Proposal for the 03 series of amendments to UN Regulation No. 79 (Steering equipment)

Submitted by the Working Party on Brakes and Running Gear*

03 series of amendments to UN Regulation No. 79 (Steering equipment)

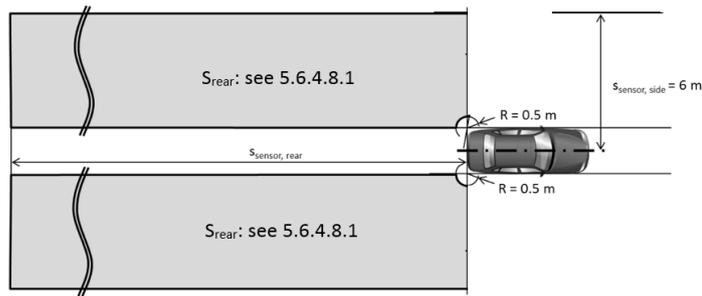
- 5.6.4.8.2. The vehicle system detection area on ground level shall be at minimum as shown in the figure below.
